FIELD CHANGE ORDER	Number: CI750-I005
--------------------	--------------------

Applicability: The L0118 Rev B* module should be installed on all CI750, CI780, CIBCI, & HSCxx nodes used in VAXclusters of 6 (six) or more CI/HSC nodes connected to a common SC008 Star Coupler. L0118s should replace all L0100 Rev D* link modules; L0100 Rev E* can coexist with L0118s except in greater than 16 node environment.

FCO CI750-I005

SET L0100-E1 COMPATIBILITY JUMPER AS FOLLOWS:

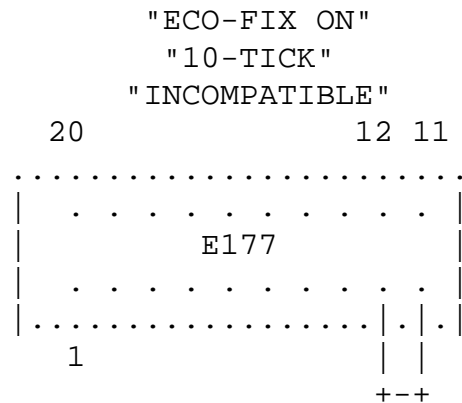
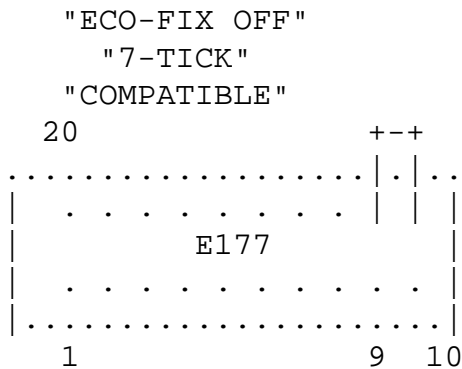
o 7/10-TICK COMPAT. MODE SET BY 1 JUMPER @ E177 stake-pins.

- "7-TICK COMPAT.-MODE": jumper E177-11 to E177-12
 - "10-TICK INCOMPAT.-MODE": jumper E177-9 to E177-10

o L0100-E1 QUICK-CHECK (PART-REVISION VERIFY):

- ECO wires at E177-13 and E177-9.
 - STAKE-PINS (for jumper) @ E177-9,10,11,12.
 - ETCH REV-C: P/N "50-14430C-0" marking.
